HOSHIZAKI AMERICA, INC.

SERVICE BULLETIN

SB03-0002R1

Subject: WATER INLET FITTING CHANGE (AM and "B" SERIES KM)

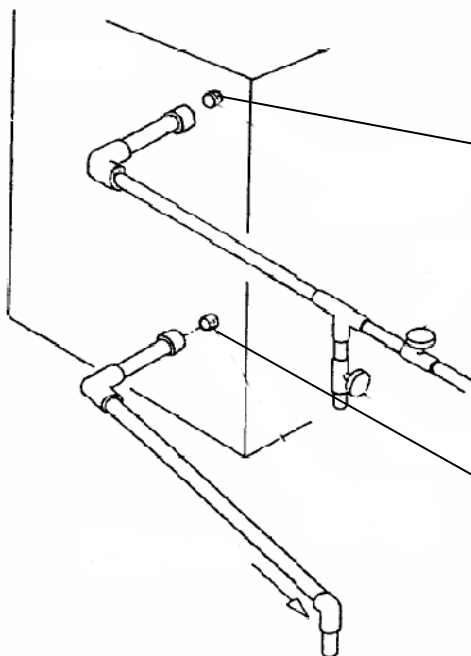
Beginning with the May 2003 production the AM series included a brass 3/4" BSP x 3/8" male flare connector (4A3207-01) either in the accessory bag or installed on the unit. This change was made on an interim basis to standardize the fittings necessary to install the AM series inlet water line.

Starting on July production, we will begin phasing this fitting out for the AM series as well as the current water inlet fittings provided on KM-150B_F and KM-250B_F units. The new replacement fitting will be a 3/4" BSP to 1/2" FPT (4A3240-01), making the water inlet connection consistent with other Hoshizaki products.
